# UNITED STATES PATENT AND TRADEMARK OFFICE

APPLICATION NO.	FILING DATE	FIRST NAMED INVENTOR	ATTORNEY DOCKET NO.	CONFIRMATION NO.
10/019,475	08/09/2002	Willi Neff	127FR/50787	5559

## Office Action Summary

## **DETAILED ACTION**

**Figure 5 – U.S. Patent 6,031,241 to Silfvast et al.**

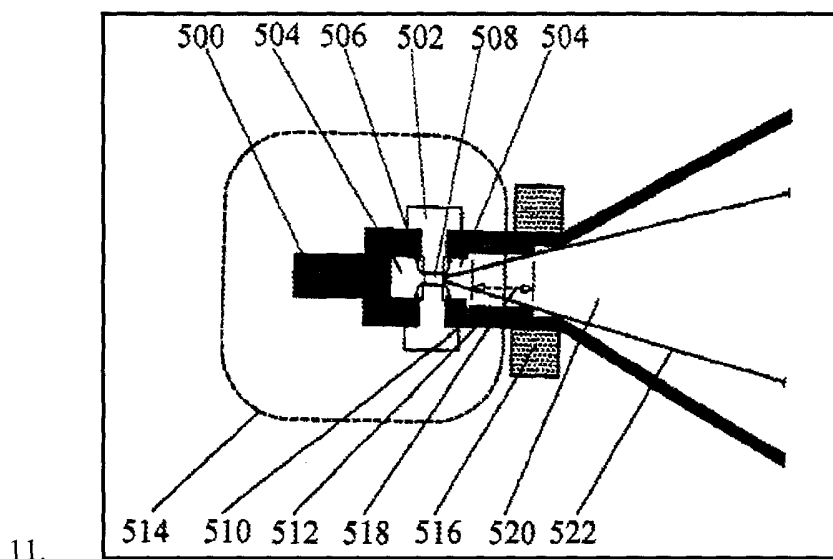
12. **As per claim 1**, Silfvast et al. disclose a device comprising two main electrodes (**500, 510**), between which there is a gas filled space (not labeled above), wherein each of the two main electrodes (**500, 510**) exhibits an opening, defining an axis of symmetry, and wherein the electrodes (**500, 510**) are formed in such a manner that a gas discharge forms exclusively in the volume, determined by an alignment of the openings; and where a plasma channel (**508**) generated on the axis of symmetry is the source for at least one of the extreme ultraviolet (EUV - **522**) and X-rays and means for increasing conversion efficiency (**514, 516, 512, 520** – see Fig. 5, above).

13. **As per claims 2-7 and 11**, Silfvast et al. disclose a device wherein at least one of the openings on the side facing away from the space is larger than on the side facing the space; wherein the openings exhibit the shape of a truncated cone and wherein an auxiliary electrode (**512**) is provided behind the opening of one of the main electrodes and a pulse forming network is provided as a power supply (see Fig. 5, above – column 1, lines 29-67; column 2, lines 1-52).

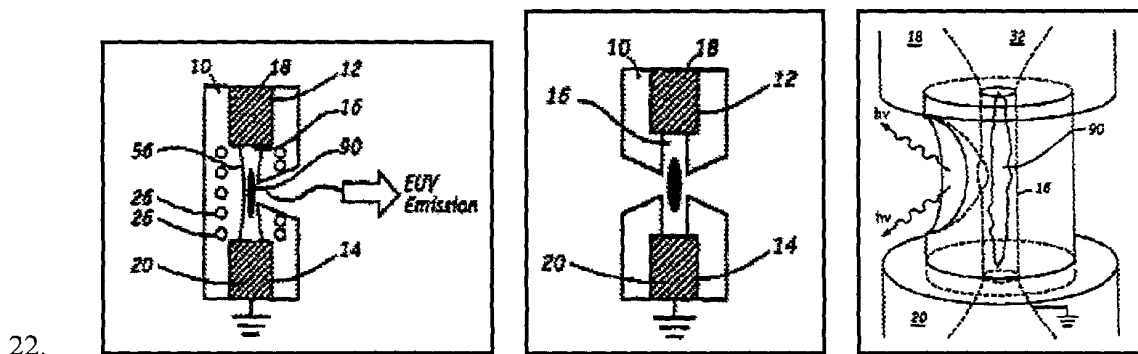
23. U.S. Patent 6,654,446 to Bender, III discloses several structures for EUV emission (see above Figs).
